GREEN VALLEY RANCH EAST
PRELIMINARY SITE PLAN #5
TITLE: KEYMAP
DATE: March 24, 2022

GREEN VALLEY RANCH EAST
PRELIMINARY SITE PLAN #5
TITLE: LANDSCAPE PLAN
DATE: March 24, 2022

GREEN VALLEY RANCH EAST
PRELIMINARY SITE PLAN #5
TITLE: LANDSCAPE DETAILS
DATE: March 24, 2022

TYPICAL BUNGALOW 6-PACK LANDSCAPE

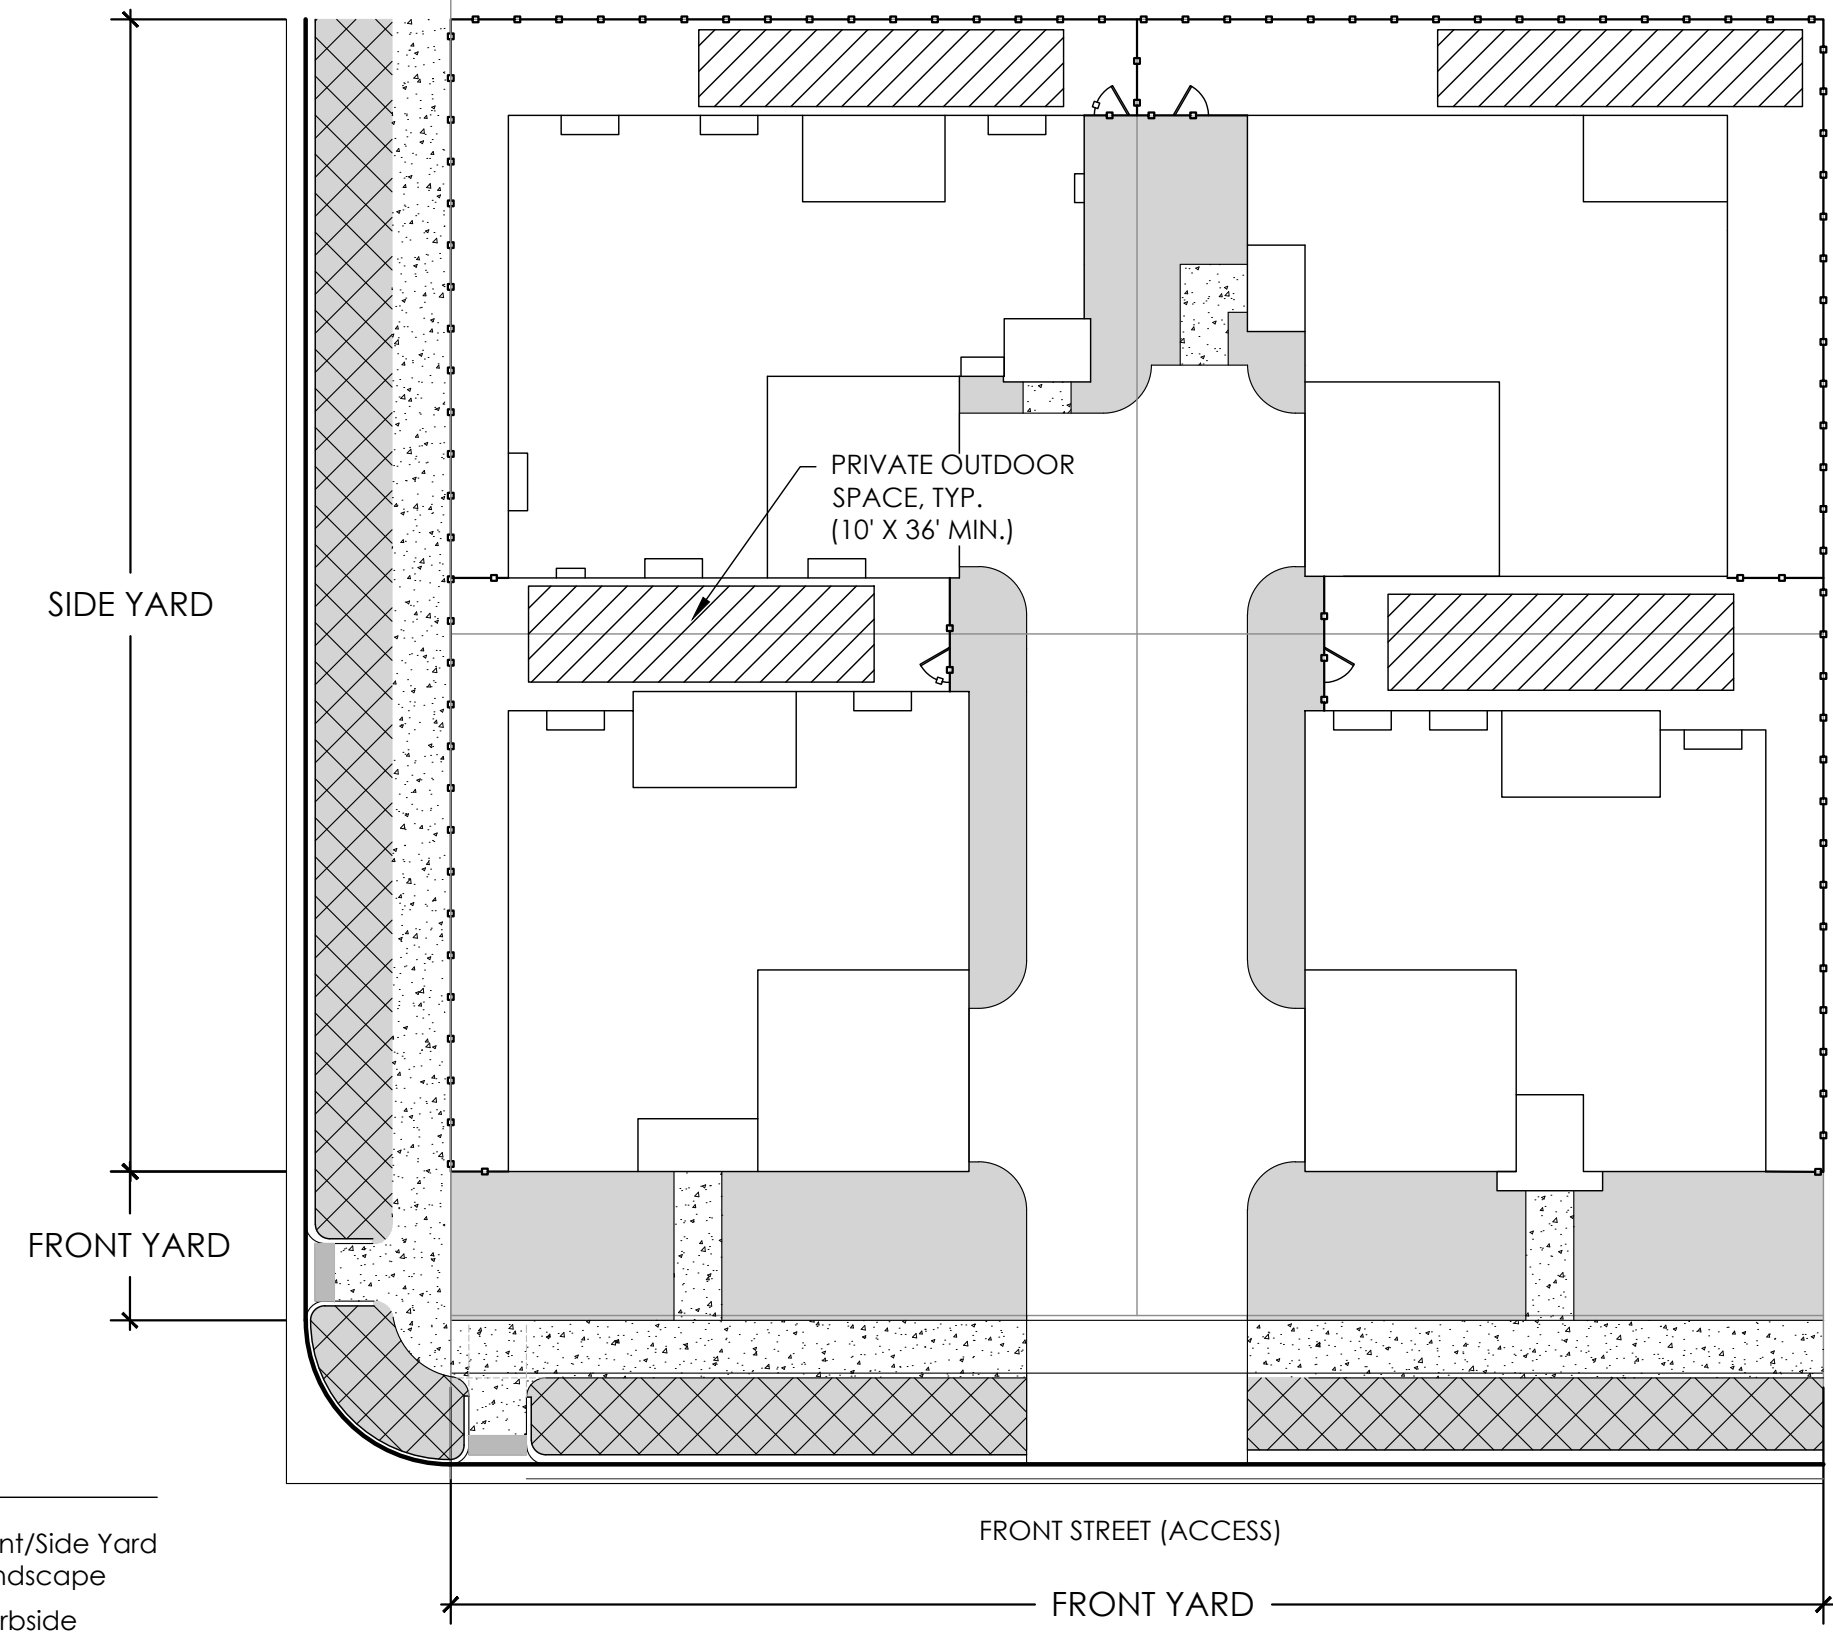
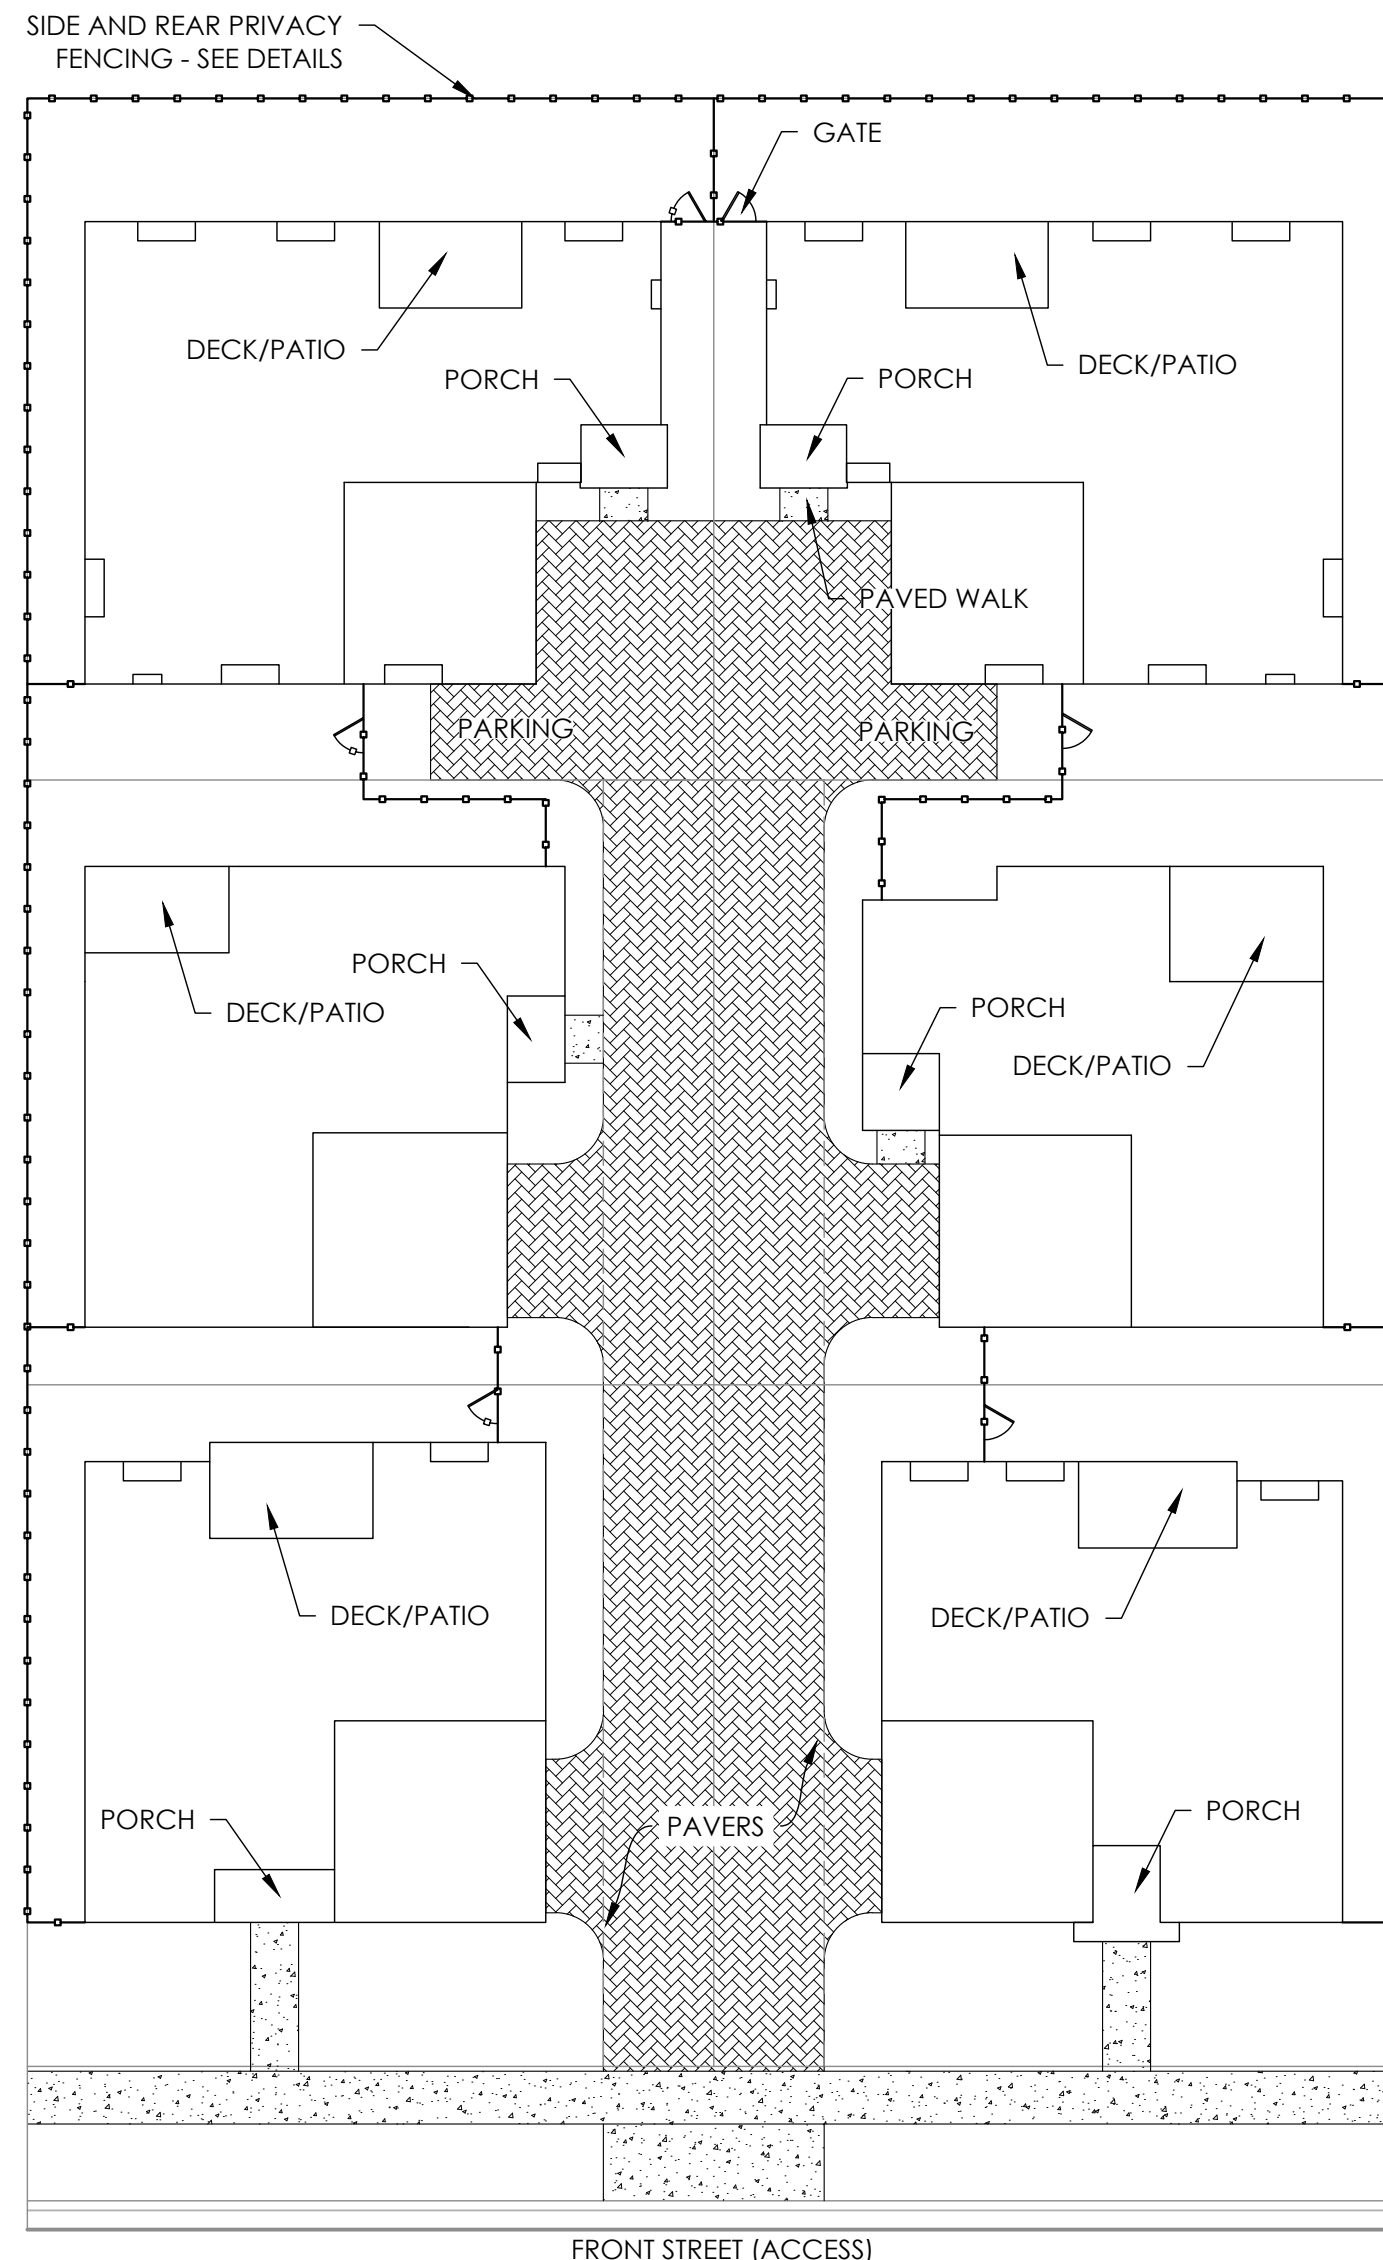
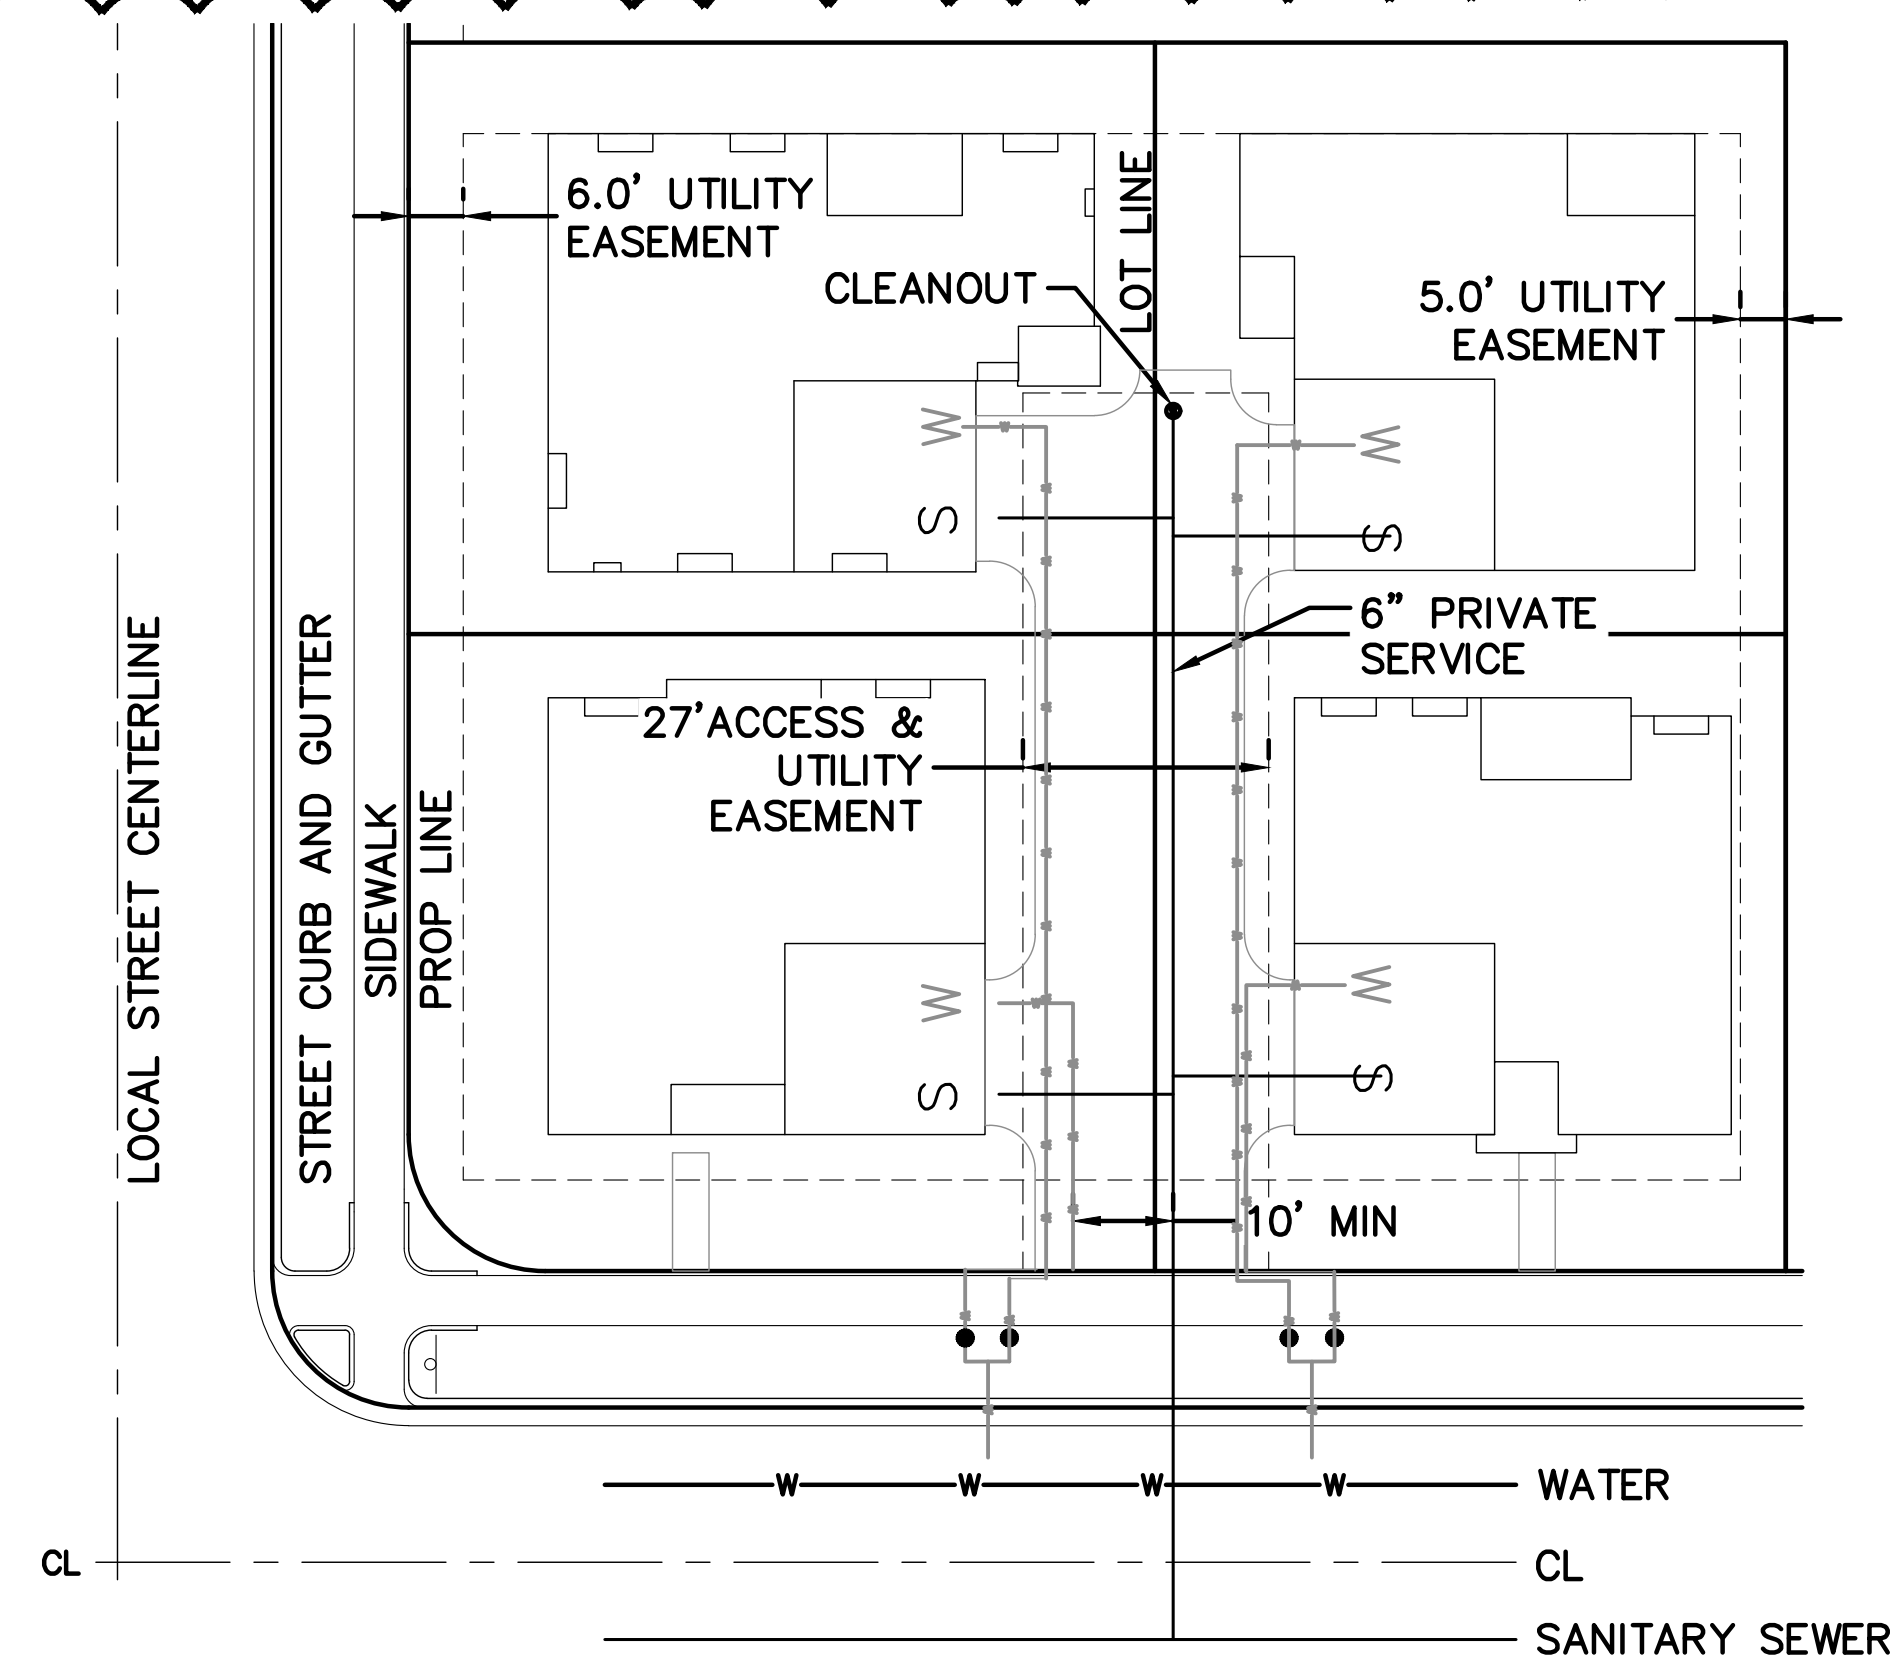
1
AMENDMENT 1
- BUNGALOW 6 PACK TYPICALS ADDED
